Casey Fields South Employment & Devon Meadows PSP, DSS & Amendment C295case

Issued
31 March 2025

Executive Summary

The landowners of 1934 and 1884 South Gippsland Highway, Devon Meadows, Kardinia Developments Pty Ltd, make this submission to the Casey Fields South Employment and Devon Meadows Precinct Structure Plan (CFS&DM PSP), the Casey Fields South Employment and Devon Meadows Development Services Scheme (CFS&DM DSS) and Planning Scheme Amendment C295case.

Figure 1-1 Current Proposed Scenario (GHD, 2025)

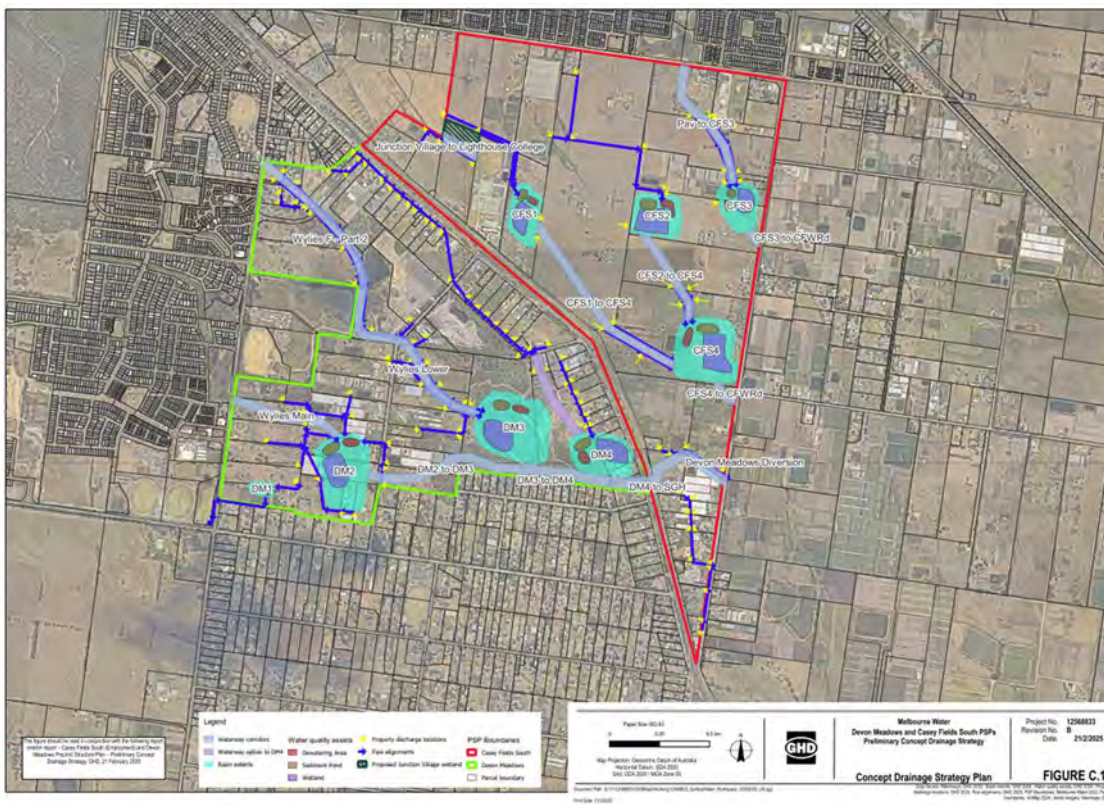
The proposed drainage layout provided by Melbourne Water in the *Interim Report – Casey Fields South (Employment) and Devon Meadows Precinct Structure Plan Preliminary Concept Drainage Strategy* from the 21st February 2025 is shown in **Figure 1-1**. This represents a change from the original scenario, with the outfall now proposed to be directed to the east from DM4 to the Casey Fields PSP. Waterways have been realigned and an additional waterway through from Rawlins Road to DM4 has been included.

- ▶ The impact of increased flows on the receiving waterway, and downstream properties, needs to be tested at Manks Road. This could impact the size of the retarding basins DM2, DM3 and DM4.
- ▶ New climate change guidelines need to be used in the design of the basins, which will likely impact the size of the basins and other drainage assets. This could represent an increase in rainfall from 18.5% under ARR V4.1 to 70% in ARR V4.2, depending on which pathway is selected.
- ▶ The DSS design is contingent on the Department of Transport approval to install a crossing under the highway.
- ▶ Approximately 26 significant trees are in the path of proposed waterways and retarding basins.

Figure 2-1 Drainage Option 1

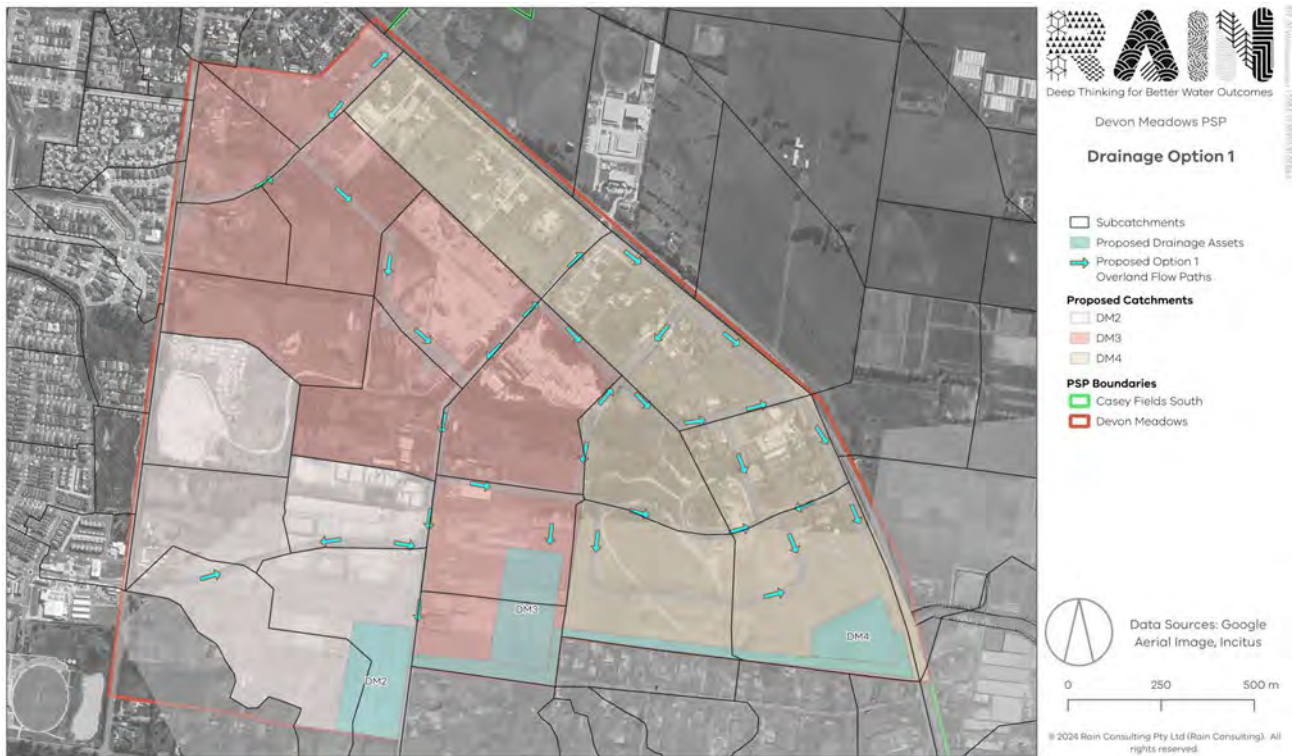
- ▶ Option 1 – relocate DM3 to the west to avoid significant trees. These trees are currently the subject of an environmental investigation to determine their significance. Refer to **Figure 2-1** for the proposed locations.
- ▶ Option 2 – combine DM2 and DM3 into one asset at the original location of DM2. Refer to **Figure 2-2** for the proposed locations.

The two options proposed provide an environmental benefit through the retention of significant trees.

Figure 2-2 Drainage Option 2

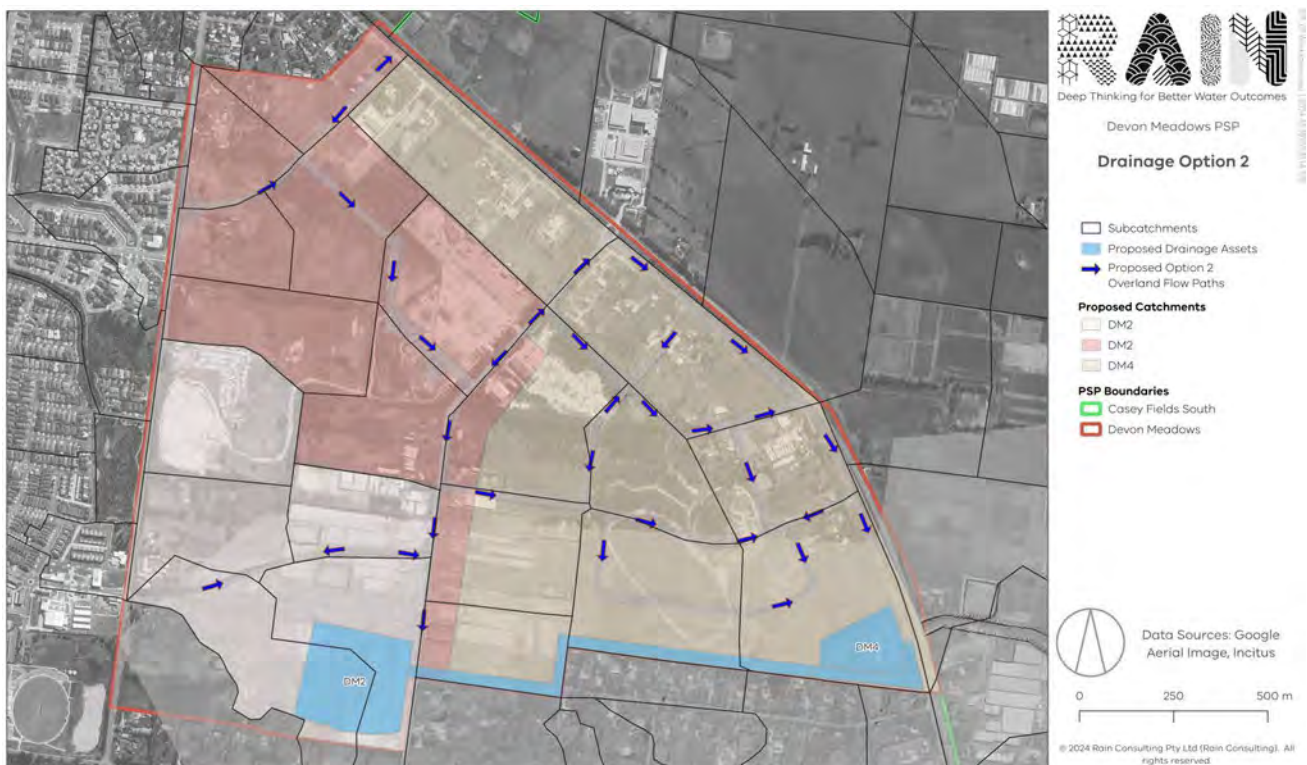
Option 2, in particular seeks to provide cost savings to the entire scheme by removal of an asset, thereby reducing construction costs and ongoing maintenance costs.

Figure 2-4 Option 1 RORB Setup

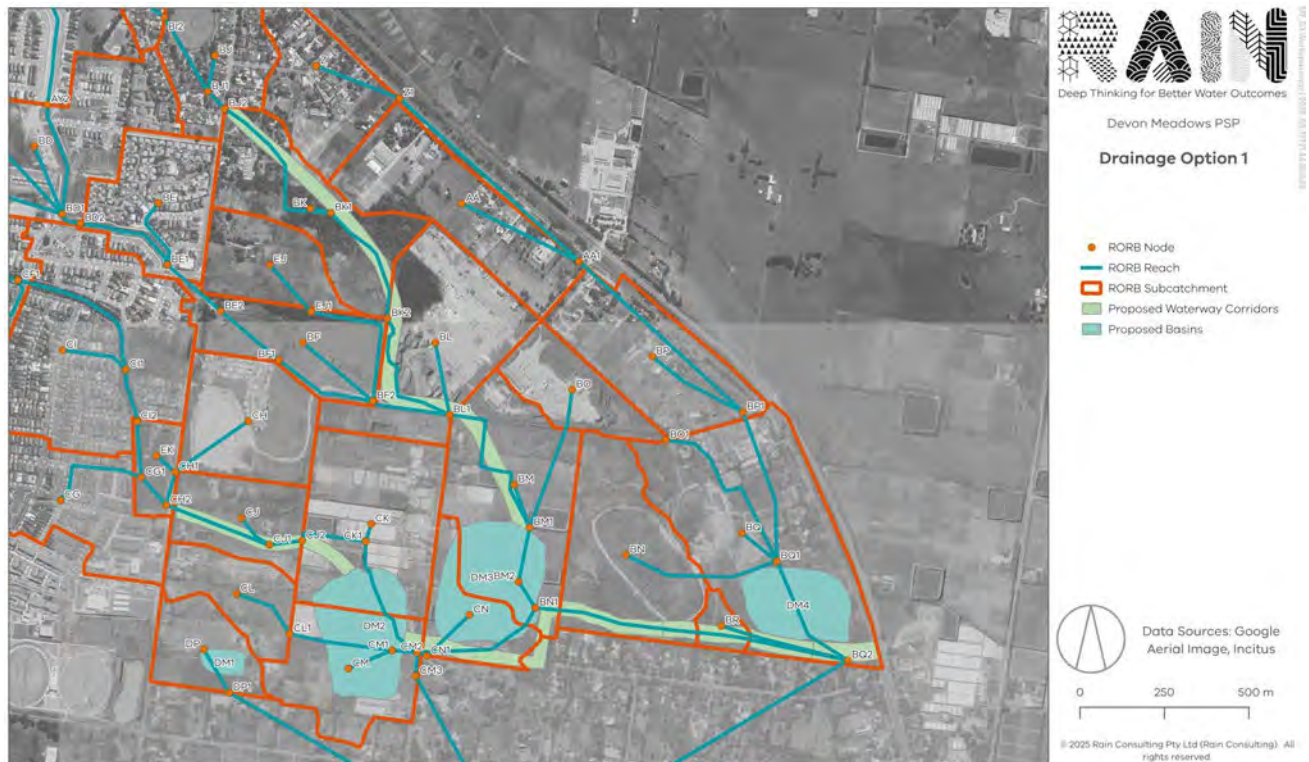
Overall catchment changes were made as per **Figure 2-4**, **Figure 2-5** and **Table 2-1**. It is noted that a consistent Fraction Impervious value was used in the Melbourne Water developed RORB model of 0.75, including the locations of proposed drainage assets. This is seen as a conservative approach, but for this stage of the project, and for consistency in comparing options, these fraction impervious values were retained. Reaches and centroids were adjusted accordingly.

Figure 2-5 Option 2 RORB Setup

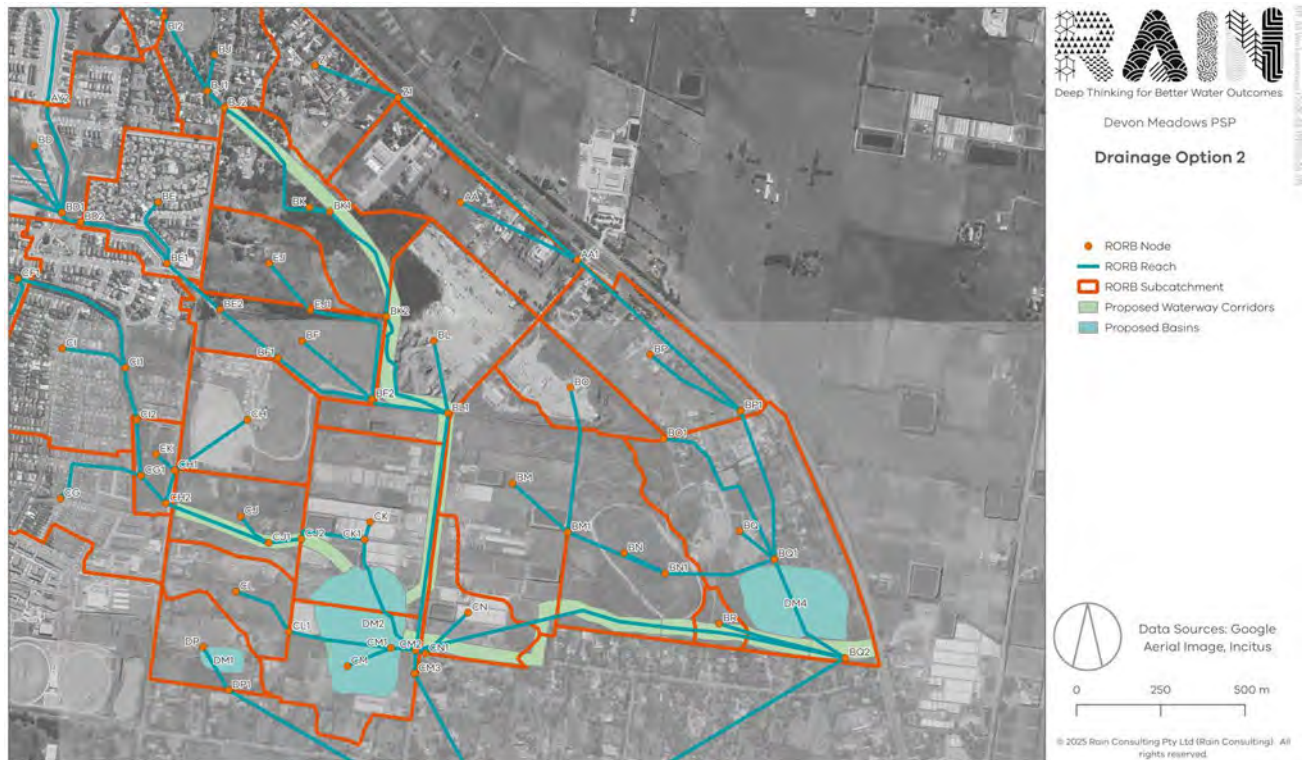
It is noted that the stage storage discharge relationship was modified for Option 2 to optimise basin storage and sizing.
